ACTIVITY T19BU00078

PROJECT ADDRESS: 2121 N EVELYN AV TUC

DESCRIPTION OF PROPOSED WORK: POOL RENOVATION

Plan Review Comments: (Responses provided by Anna kanto from Imperial pools and design)

TITLE:	PLUMBING AND CONSTRUCTION PLAN REVISION 1
DRAWING #	2 OF 3
SCALE:	1/8" = 1'
DRAWN BY/DATE:	AK 2/11/19

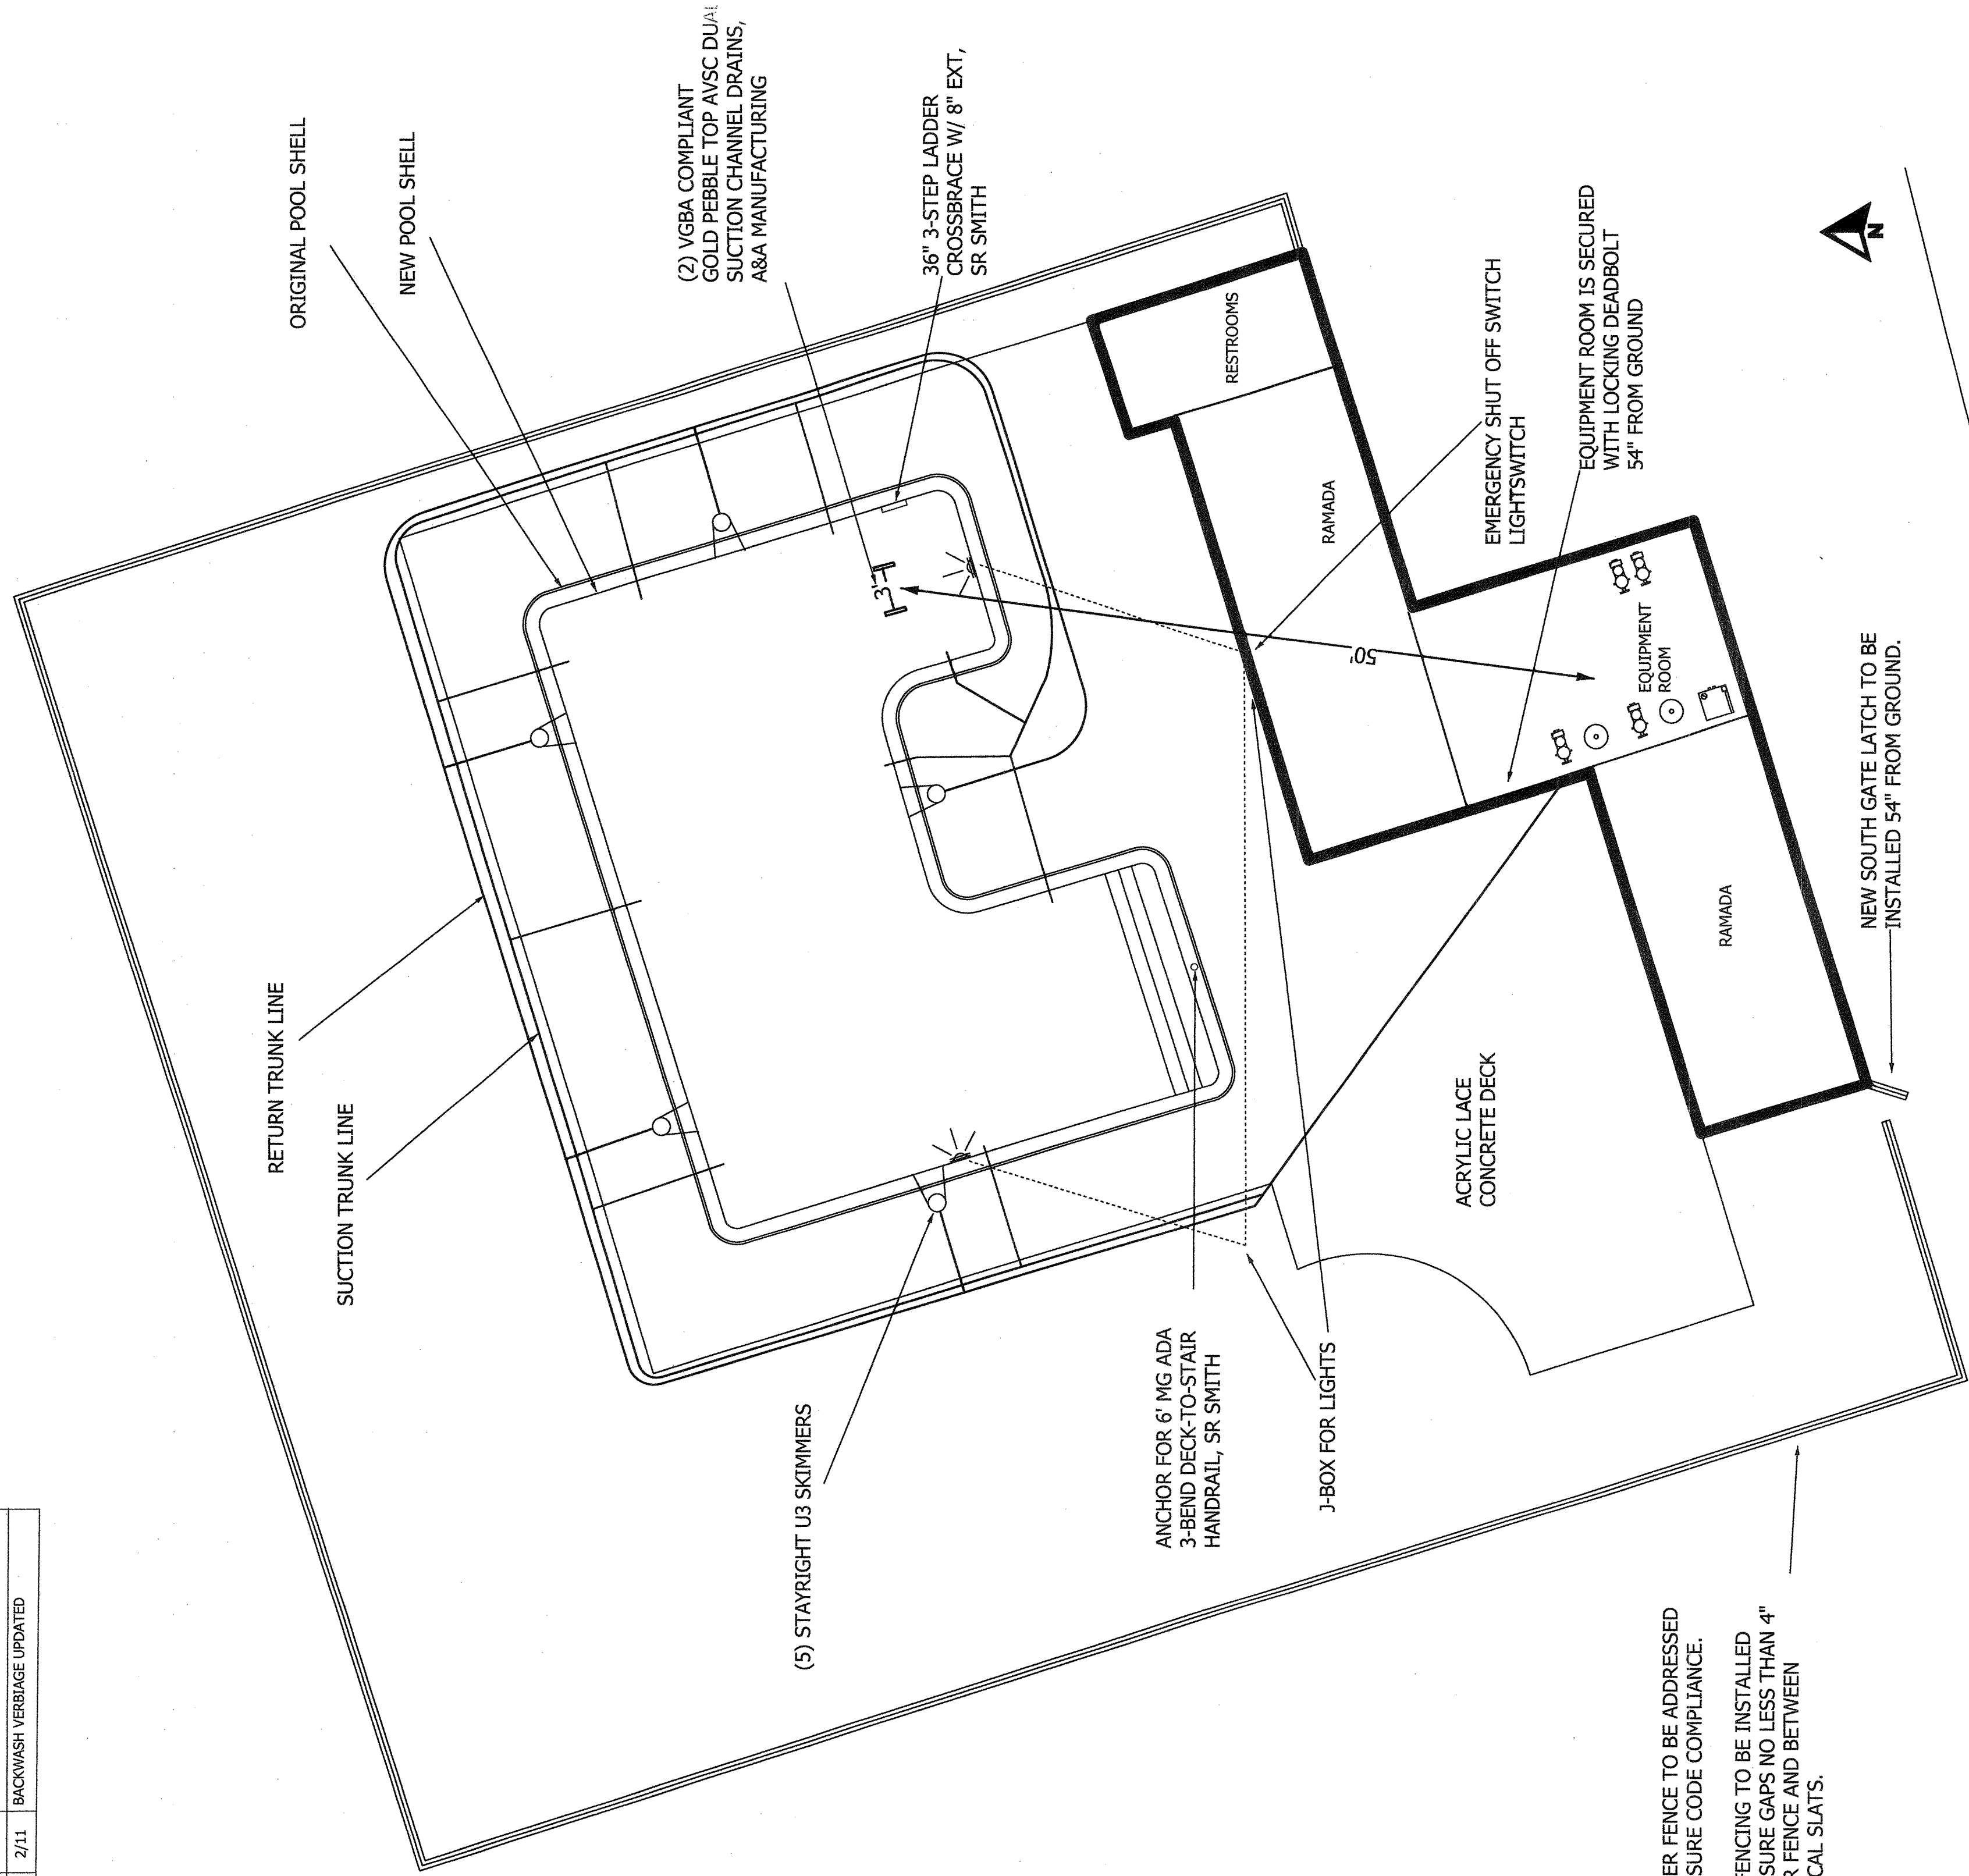
→ Show the complete barrier on the plan. All entry points shall be shown, the type of locking mechanism, and its height AFF, the barrier design shall confirm there are no spacing's under the fence, or between the vertical members greater than 4". All barrier requirements applicable to your facility must be in compliance.

→ **Provide make and model numbers for both the handrail, and the ladder.**

→ **Provide the material, and color of the required accent tiles on the steps.**

→ **Provide the make and model of the channel drain, and a plumbing page confirming the required dual drains are provided.**

→ **Where is the filter back wash disposed of? There is no reference to the backwashing method. Show the required air gap, and the piping system that will be draining the backwash of the filtration system. System.**

BARRIER FENCE TO BE ADDRESSED TO ENSURE CODE COMPLIANCE.

NEW FENCING TO BE INSTALLED TO ENSURE GAPS NO LESS THAN 4" UNDER FENCE AND BETWEEN VERTICAL SLATS.

- ✓ **(Operator Response)** “Barrier fence to be addressed to ensure code compliance: New south gate latch to be installed 54” from the ground, new fencing to be installed to ensure gaps no less than 4” under, and between vertical slats. All applicable state & local codes shall be followed”

- ✓ **(Operator Response) Handrail:** Anchor for 6’ MG ADA 3-bend deck-to-to stair handrail, SR Smith.

- ✓ **(Operator Response)** Accent Tiles will be Cobalt blue textile concrete tile, specification form updated.

✓ **(Operator Response)** (2) VGBA compliant gold pebble top AVSC dual suction channel drains. A&A manufacturing

- ✓ **(Operator Response)** "Backwash, will be using existing backwash drainage system to wash with airgap"

EQUIPMENT ROOM REVISION 1	DRAWING # 3 OF 3
DRAWN BY/DATE: AK 2/11/19	SCALE: NTS
PROJECT NAME: FOUNTAIN PARK RENOVATION	ADDRESS: 2121 N EVELYN PL TUCSON, AZ 85715

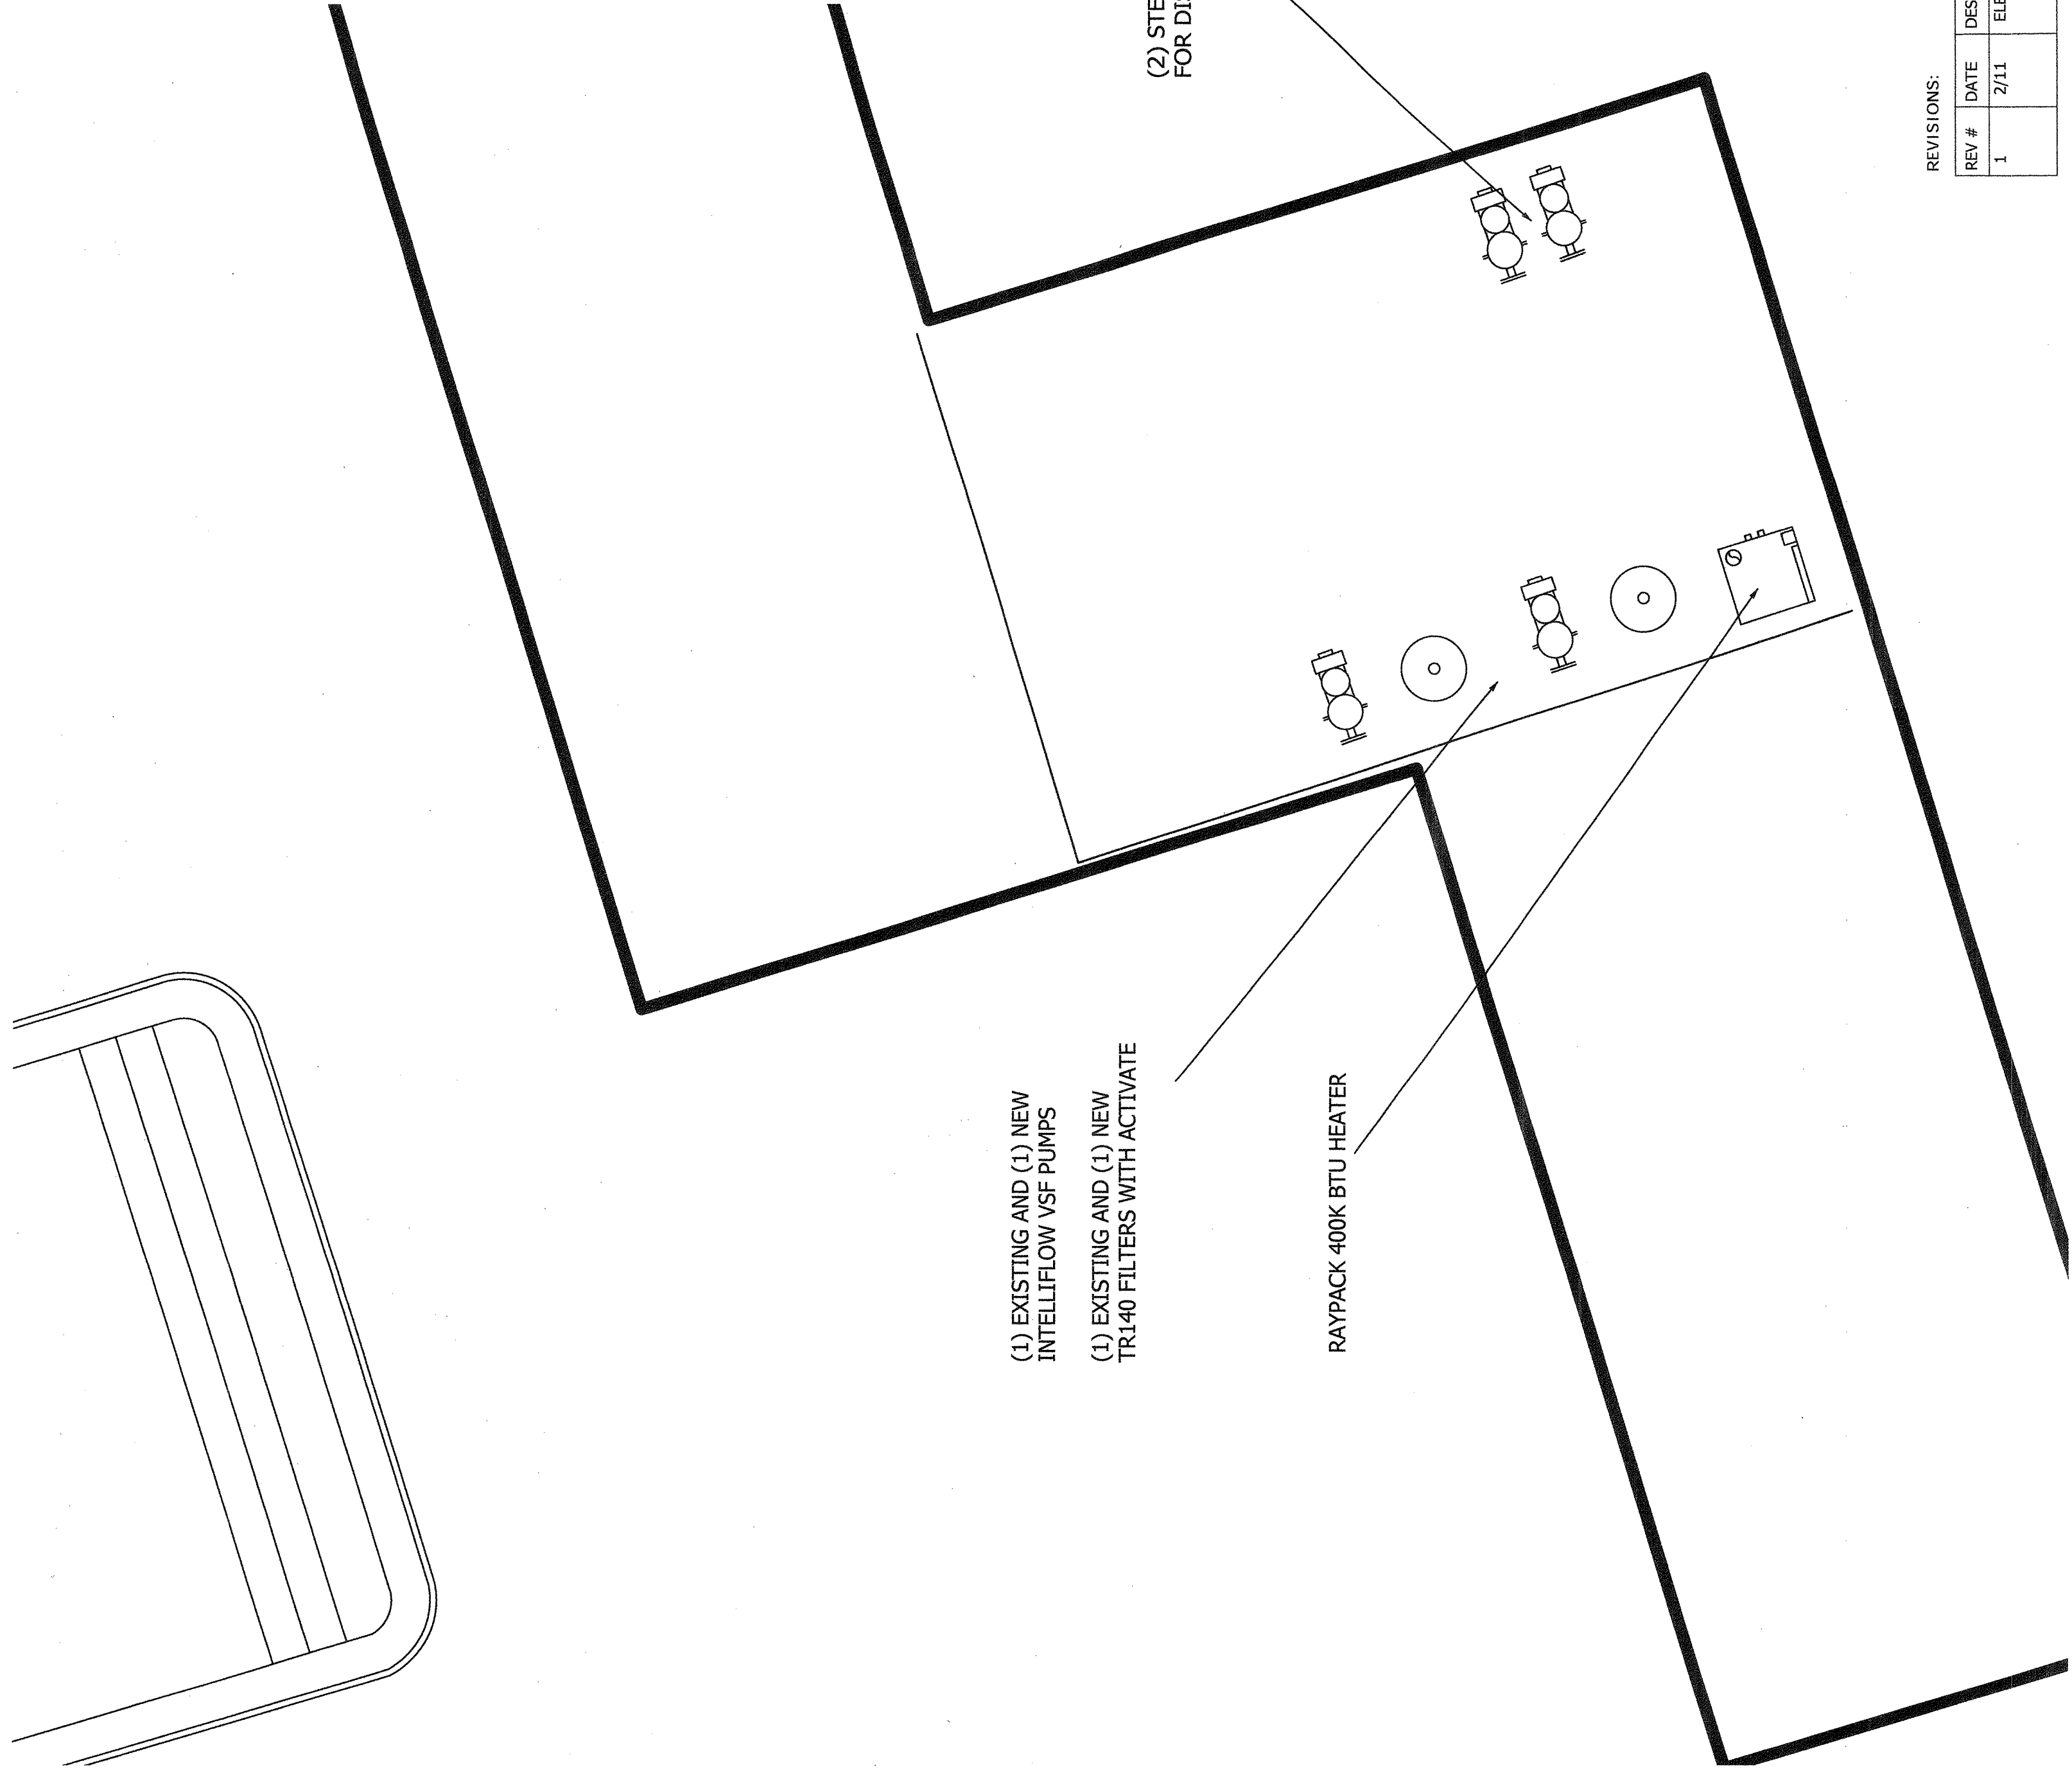
- b) Equipment room noted on plan, but no details provided regarding the enclosure.

→ **Provide details confirming the equipment room is a secured enclosure.**

- b) **There is no emergency shut off switch called out on the plan.**

→ Show the required emergency shut off switch, within the pool enclosure.

✓ **(Operator Response)** Verbiage updated on plans re: security of equipment room; room is locked with deadbolt 54" from ground.

- ✓ **(Operator Response)** Plans updated to show emergency shut off switch at light switch on Ramada.
